Third Revision December 2013

Dealer Service Instructions for:

## **Safety Recall N58 / NHTSA 13V-483 Reprogram Instrument Cluster & ABS Module / Alternator Ground Wire**

**2014 (WK) Jeep® Grand Cherokee**

**Figure 1 – Alternator Ground Wire Location**

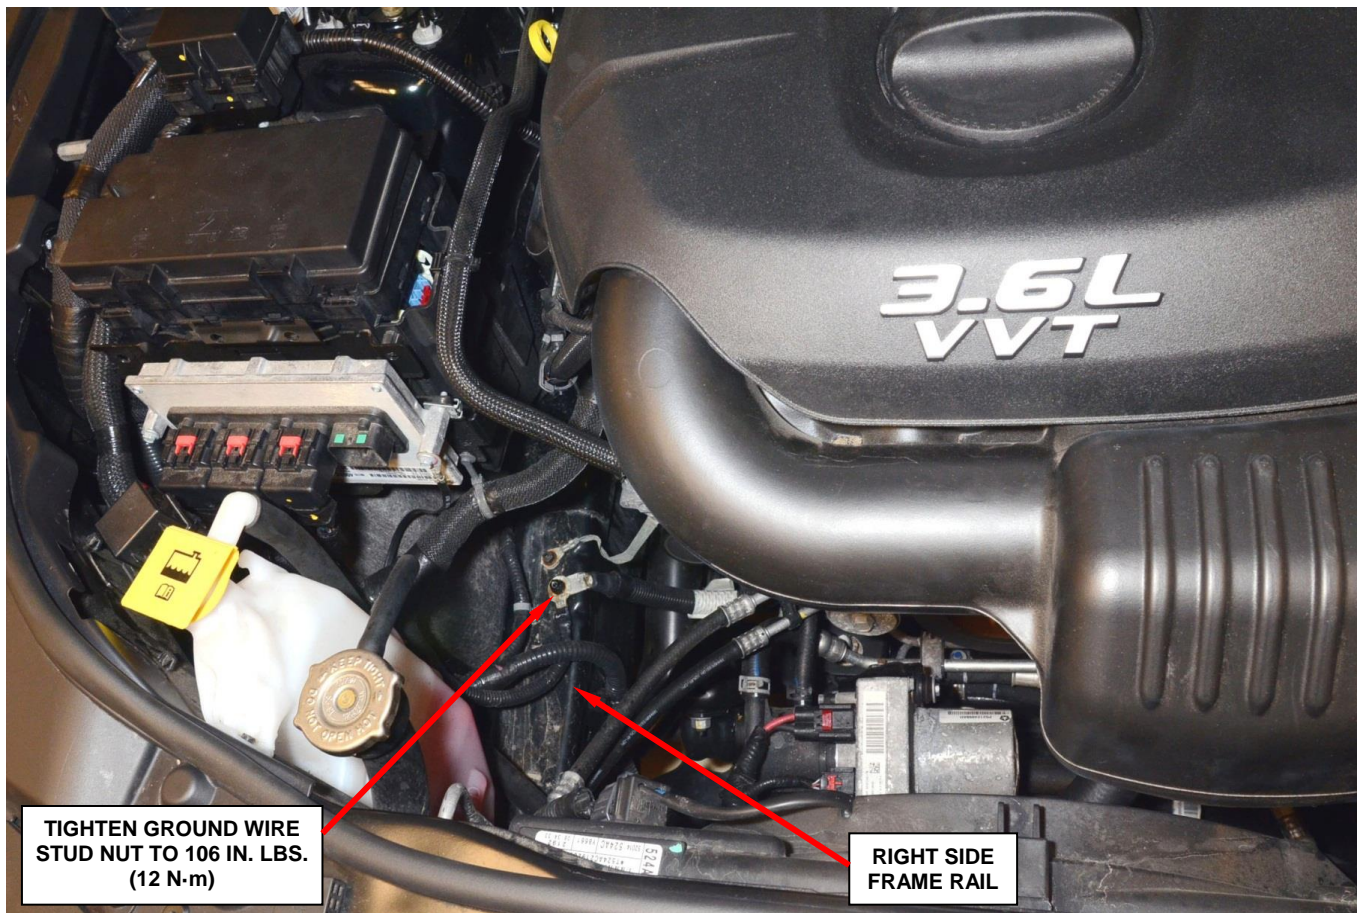
The instrument cluster and the ABS module must be reprogrammed. The instrument cluster **reprogramming procedure will take approximately 30 minutes** of uninterrupted flash time. Also, the alternator ground wire, at the right frame rail, must be tightened.

1. Open the hood.
2. Locate the ground wire stud nut on top of the right frame rail (Figure 1).
3. Using a torque wrench and 10 mm socket, tighten the ground wire stud nut to 106 in. lbs. (12 N·m).
4. Continue with **Section B. – Reprogram Instrument Cluster & ABS Module.**
